CONSTRUCTION SUMMARY
EARLGLEN INVESTMENTS INC.

LOT NUMBER	PHASE	HOUSE TYPE	CLOSING DATE	
020 BLOCK 003	1	THE KATHERINE(END)-ELEV A-3 BDRM-3 BATHS	16-Jun-26

Date Added: 14-Aug-25 Invoice Number: 8872

KITCHEN PLAN

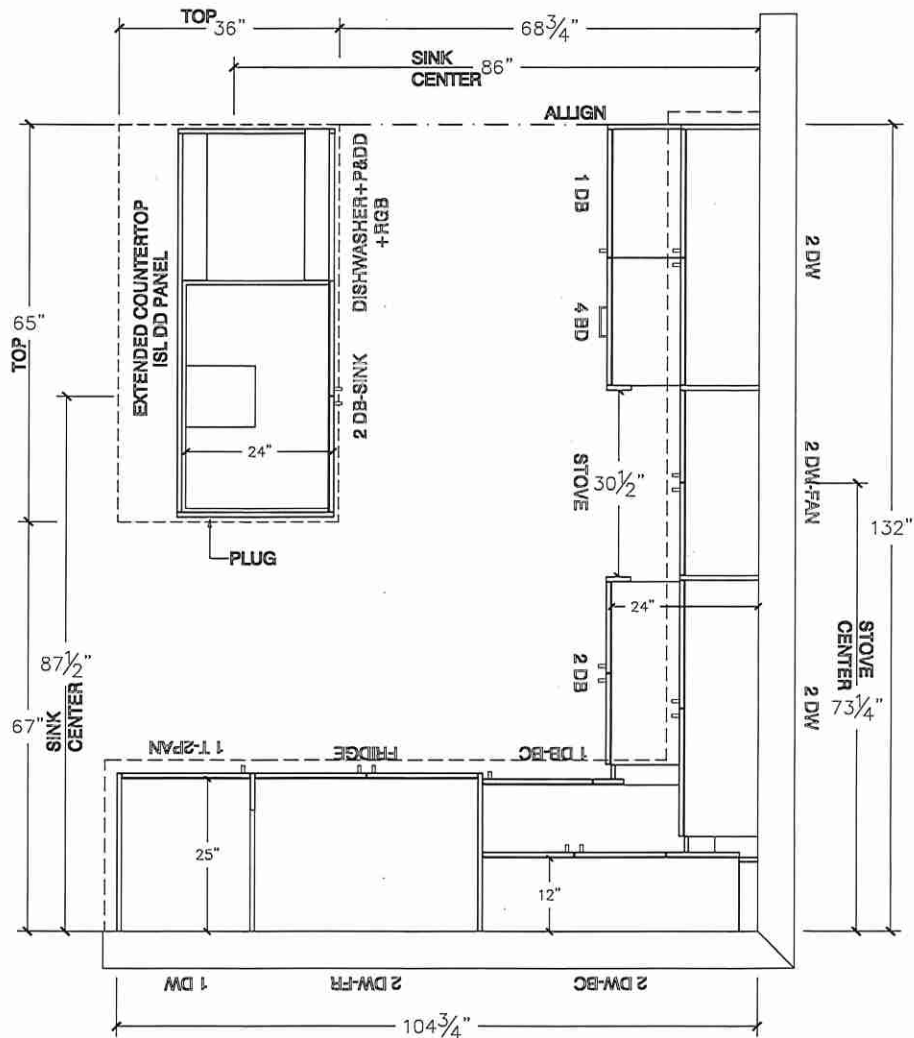
1 - PRIMARY ENSUITE - VANITY CABINETRY - Install UPGRADE Cabinetry - CATEGORY 4 - LP LAMINATE - MARIA (VG)(TX) QTM 1922 - To be installed at primary ensuite vanity, where applicable (See Sketch) Note:
1 - MAIN BATH - VANITY CABINETRY - Install UPGRADE Cabinetry - CATEGORY 4 - LP LAMINATE - MARIA (VG)(TX) QTM 1922 - To be installed at main bath vanity, where applicable (See Sketch) Note:
1 - ENSUITE #2 - VANITY CABINETRY - Install UPGRADE Cabinetry - CATEGORY 4 - LP LAMINATE - MARIA (VG)(TX) QTM 1922 - To be installed at ensuite #2 vanity, where applicable (See Sketch) Note:
1 - APPLIANCES – INSTALL STANDARD APPLIANCE PACKAGE (See Attached) Note:
1 - KITCHEN - COUNTERTOP - Install Builders Standard Stone Countertop – EVEREST VANILLA WHITE with STANDARD " A " EDGE PROFILE - To be installed throughout kitchen, where applicable (does not include stone backsplash) (See Sketch) Note:
